"Check Brake System" Displayed in MID at Startup

Service Category Brake

Section Brake System

Market USA

Figure 2: Health Check Results

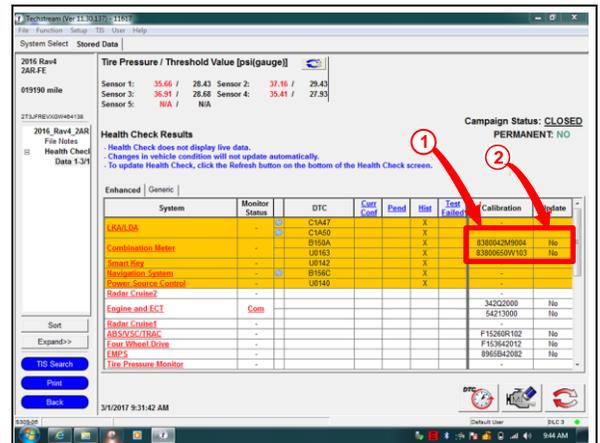
3. Using Techstream, perform a Health Check to confirm if the skid control ECU calibration has been updated.
Is the calibration ID listed the latest skid control ECU calibration?
 - **YES** — This bulletin does NOT apply. Continue diagnosis using the applicable Repair Manual.
 - **NO** — Continue to step 4.

- Flash reprogram the skid control ECU with the applicable NEW Calibration ID as indicated in the Calibration Information table on pg. 2.
